Technical Service Bulletin: tsb100884

Released Date: 06-Feb-2010

New Ignition Coil for Shielded Ignition Systems

Cradle Shape Coil Bracket (New)

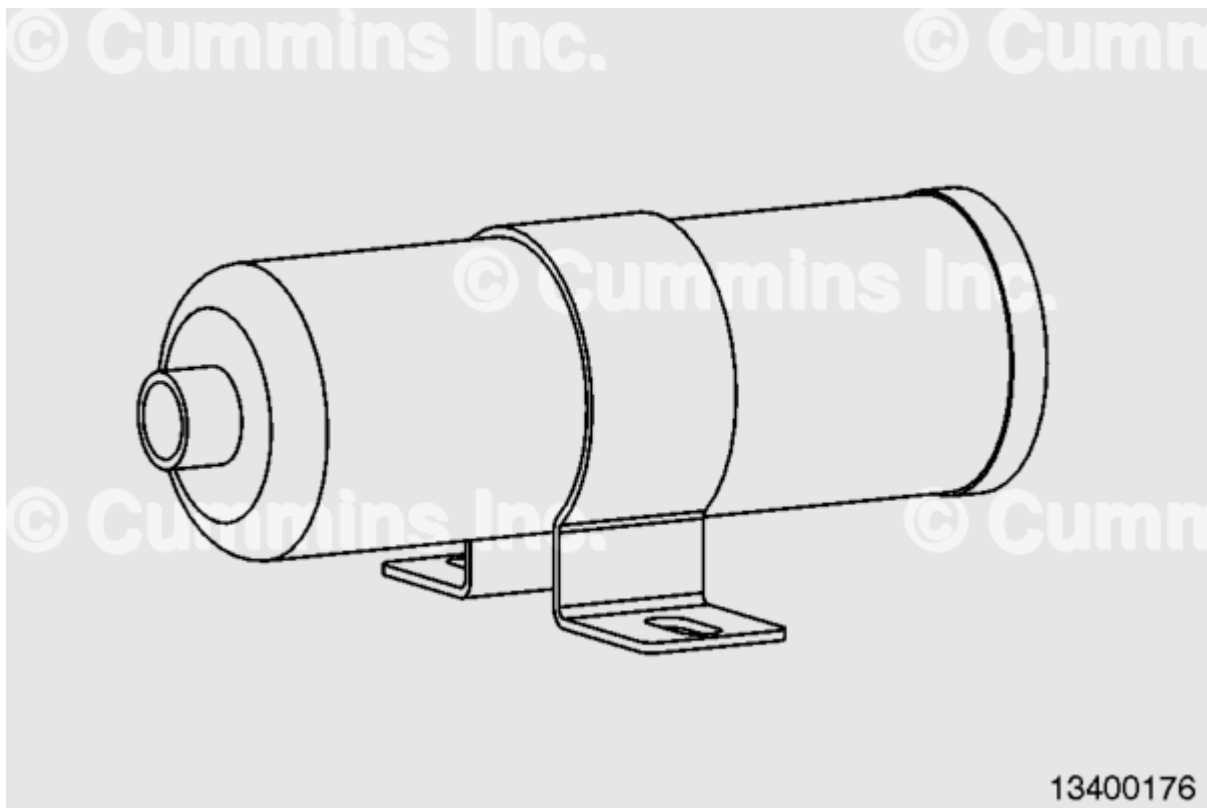
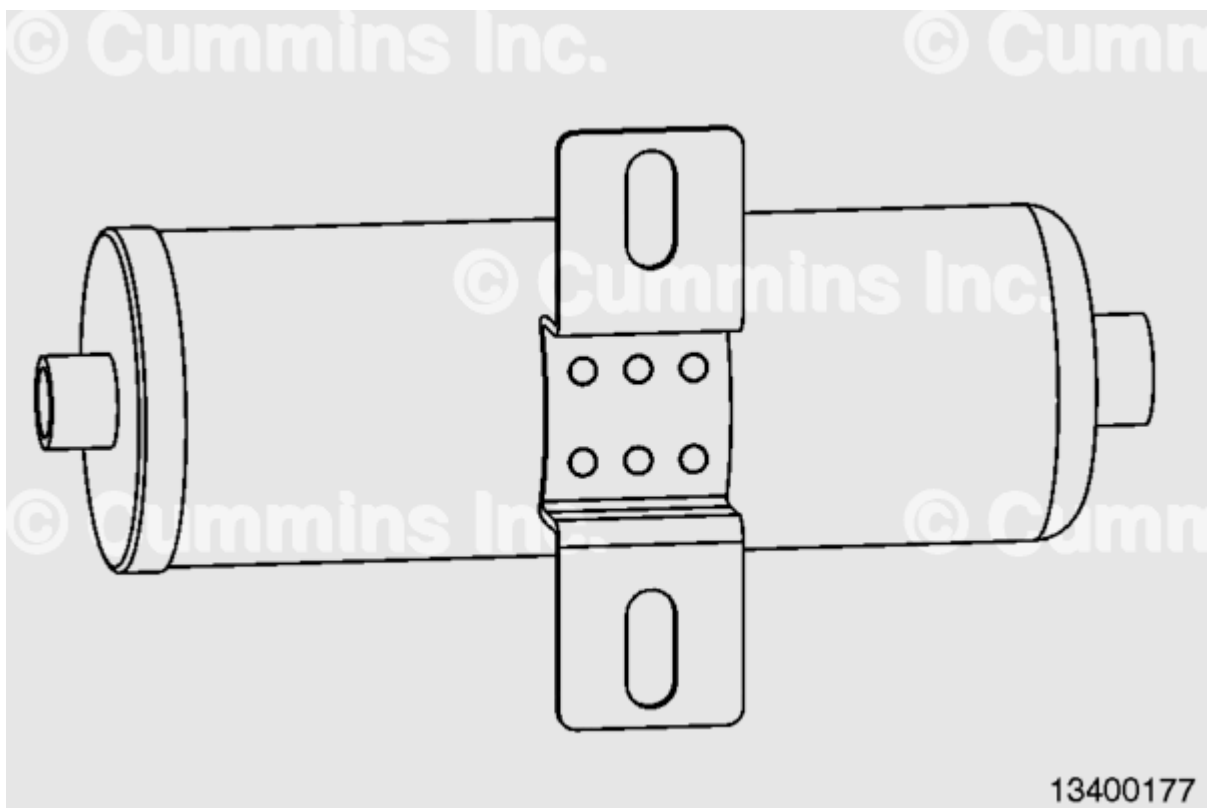
This new ignition coil, Part Number 2881178, replaces ignition coil, Part Number 4062756, for service and production on KTA38GC CM588 engines. The new ignition coil has a cradle shape bracket (see illustration). The old ignition coil has an omega shape bracket (see illustration).

When replacing an omega shape bracket ignition coil with a cradle shape bracket ignition coil, the mounting hardware needs to be upgraded. See Table 1 for details. The cradle shape bracket ignition coil with six weld points uses the same mounting hardware than the coil with five weld

New Six weld point ignition cradle bracket.

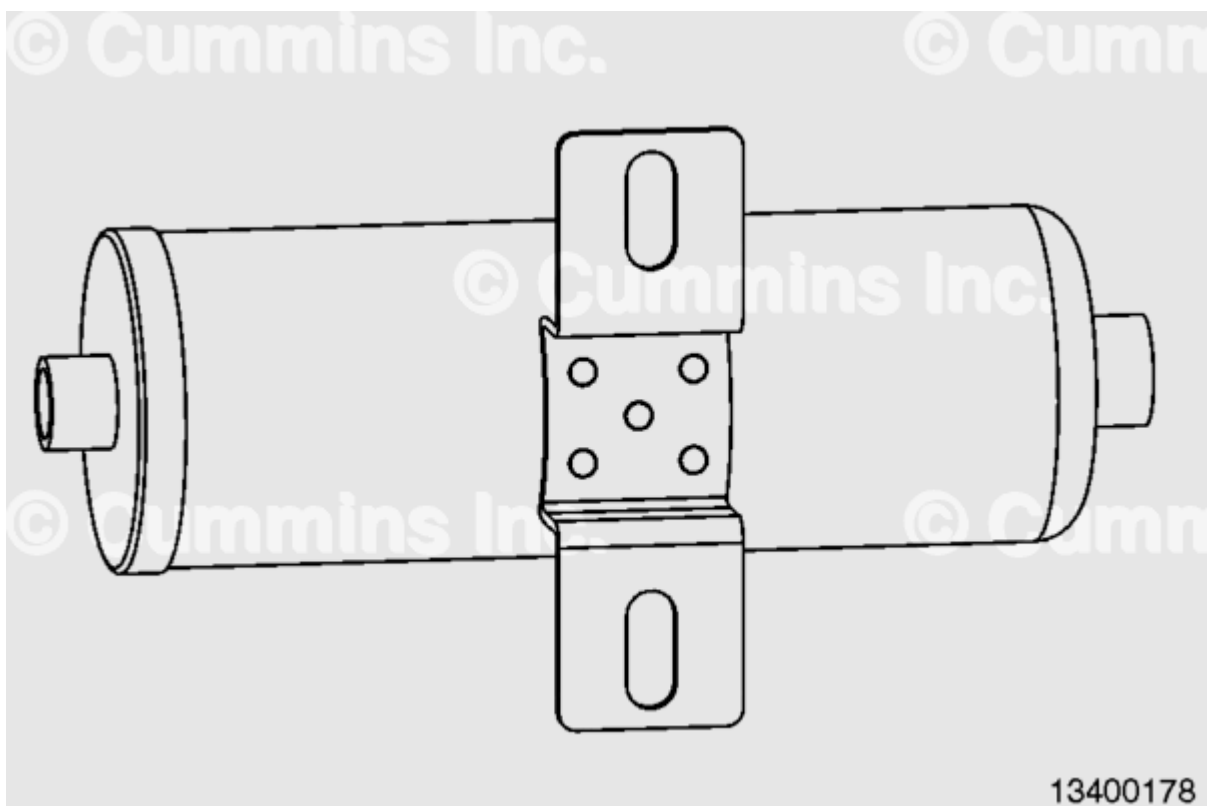
The new ignition coil, Part Number 2881178, obsoletes and supersedes the previous version of the cradle shape bracket ignition coil, Part Number 2867389, used on KTA19GC and KTA19GC CM558 engines with shielded ignition systems. The new ignition coil bracket has a revised welding pattern to improve manufacturing process control. The new ignition coil uses six weld points to attach the cradle shape coil bracket to the coil case while the previous design used five weld points. Existing parts inventory of the five weld point bracket ignition coil, Part Number 2867389, will be used to depletion prior to the use the new six weld point bracket ignition coil, Part Number 2881178.

Old five weld point ignition coil cradle bracket.
